ZONING BOARD OF APPEALS  
TOWN HALL WELLESLEY, MA 02181JOHN A. DONOVAN, JR., Chairman  
ROBERT R. CUNNINGHAM  
KENDALL P. BATESELLEN D. GORDON  
Executive Secretary  
Telephone  
431-1019 X208WILLIAM E. POLLETTA  
FRANKLIN P. PARKER  
SUMNER H. BABCOCKZBA 93-12  
Petition of Babson College  
Knight Annex Addition/Babson College Campus  
Additional Conditions

On August 20, 1993, the Board of Appeals voted to accept a second amended Roof Drainage Plan dated August 13, 1993, drawn by Richard Weber, Professional Engineer, in connection with the Special Permit granted to Babson College for the construction of the Knight Annex Addition, a Major Construction Project, in a Water Supply Protection District.

KNIGHT ANNEX BUILDING - BABSON COLLEGE · WELLESLEY, MA.

**ROOF DRAINAGE PLAN**

FIGURE No. 1

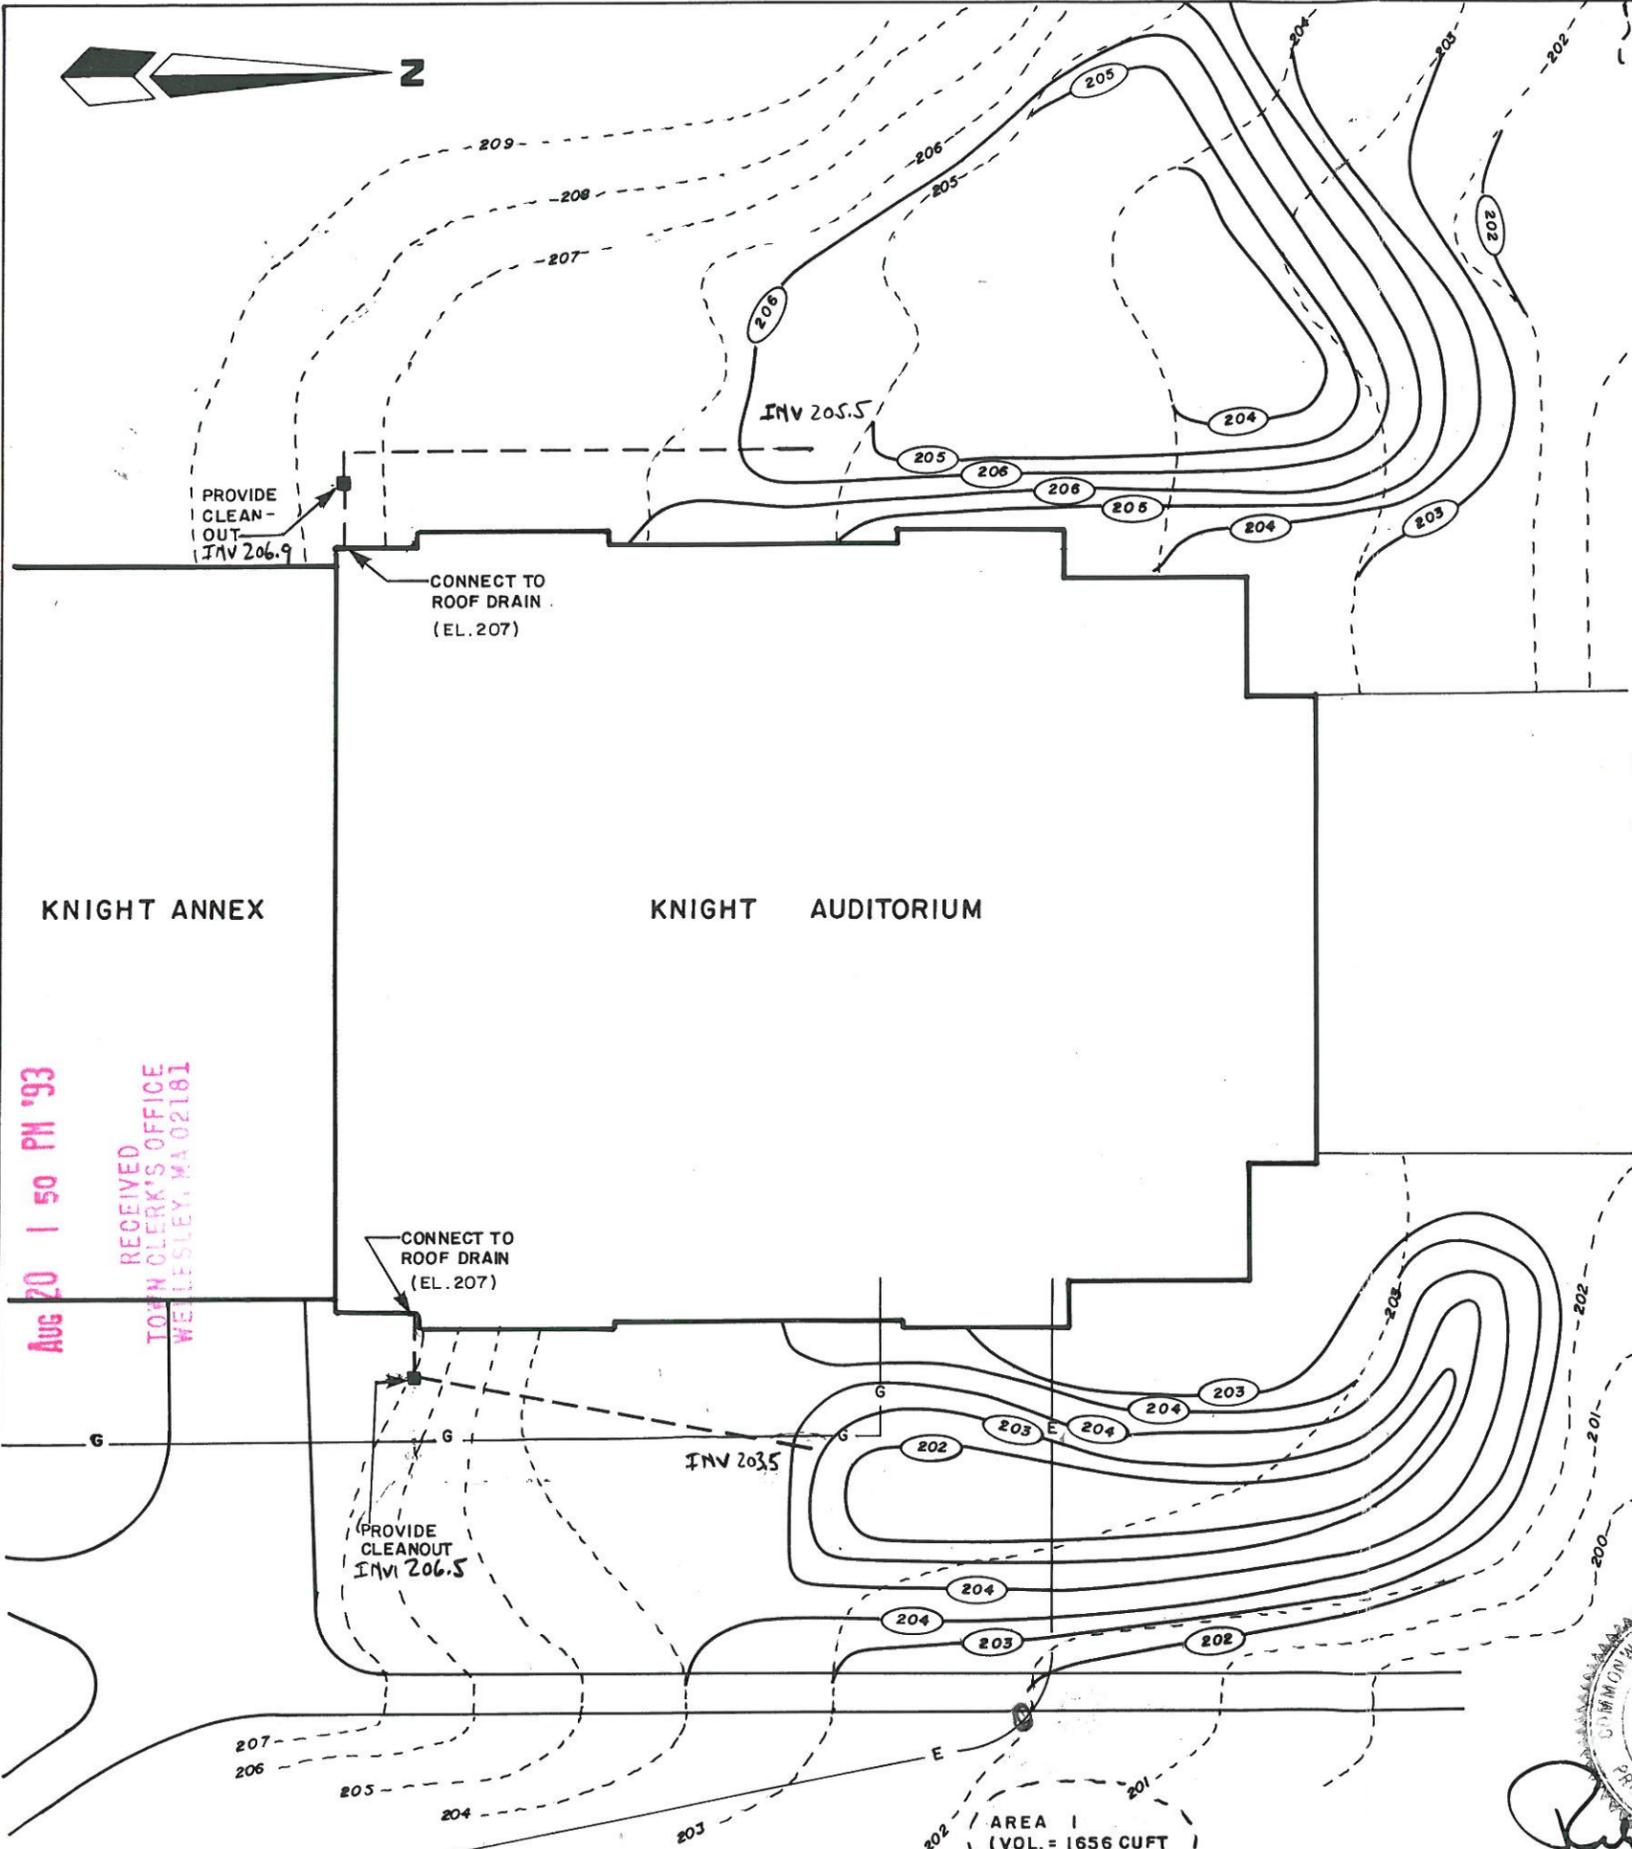
The revised Roof Drainage Plan was accepted on the following conditions:

1. Following completion of the drainage installation, an As Built Plan showing the location, depth and coverage of the electric and gas lines shall be submitted to the office of the Board of Appeals and to the Town Engineer.
2. All depths and coverage of said utility lines shall be in compliance with the requirements of the Town of Wellesley Engineering Department.
3. The installation of said Roof Drainage Plan shall be completed within 30 days of the date of issuance by the Inspector of Buildings of the Temporary Certificate of Occupancy.
4. If, during construction, it is discovered that the utilities under the eastern retention basin will not have the required ground coverage, a revised Roof Drainage Plan shall be submitted to the Wetlands Protection Committee, Town of Wellesley Engineering Department, and Board of Appeals for approval prior to excavation.
